LAND USE APPLICATION SUMMARY

Property Location: 1400 Park Avenue, 627 14th Street East, and 622 15th Street East
Project Name: 1400 Park Avenue Apartments
Prepared By: Lisa Steiner, Senior City Planner, (612) 673-3950
Applicant: BKV Group
Project Contact: Jeff Hemer
Request: To allow a new 6-story, 246-unit mixed-use building.
Required Applications:

Conditional Use Permit	To amend a previously approved conditional use permit for an increase in maximum height from 4 stories/56 feet to 6 stories/80 feet.
Variance	To reduce the required front yard on Park Avenue from 15 feet to 10 feet for the building, 5 feet for a retaining wall and walk-up entry, and 0 feet for planter walls.
Variance	To reduce the required front yard on 14 th Street East from 15 feet to 8 feet for the building, 4 feet for two-story bump-outs and an exhaust vent, and 0 feet for landings/patios and planter walls.
Variance	To reduce the required front yard on 15 th Street East from 15 feet to 10 feet for the building, 5 feet for a retaining wall and patio, 4 feet for two-story bump-outs, and 0 feet for landings/patios.
Variance	To increase maximum fence height in a required front yard from 4 feet to 5 feet 6 inches

C8-1

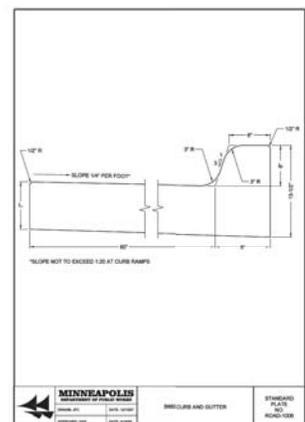
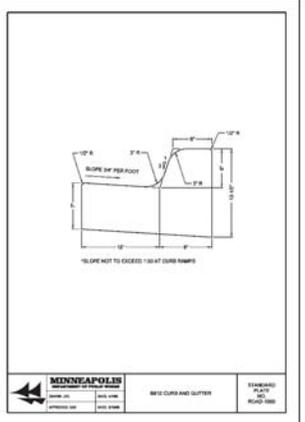
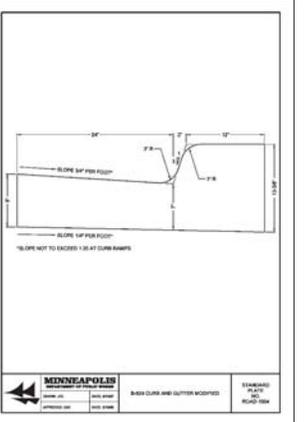
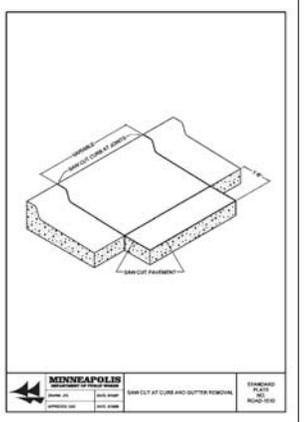
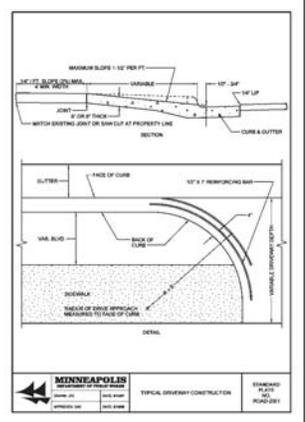
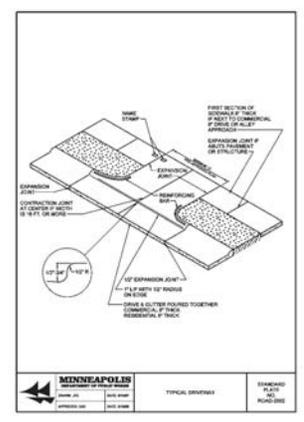
- The proposed driveway apron is shown incorrectly, with radius and curbs that exceed minimums. All driveway aprons shall be designed and constructed to City standards. All driveway aprons shall be shown graphically correct on all related plan sheets. Please refer to the following: http://www.minneapolismn.gov/publicworks/plates/public-works_road, and the standard plates included on Sheet C8-1 of the plans.

- The curb & gutter details included on Sheet C8-1 of the plans do not appear to match existing conditions. All curb & gutter in the Public right-of-way shall be designed and constructed to City standards, curb & gutter to be City Standard B624 Curb and Gutter. If curb replacement along Park Ave. S. is required, replacement curb shall be City Standard B660 Curb & Gutter. Please refer to the following: http://www.minneapolismn.gov/publicworks/plates/public-works_road. Add the following details from the ROAD-1000 Series - Curbs and Gutters to the plans: ROAD-1003 and Road -1006.
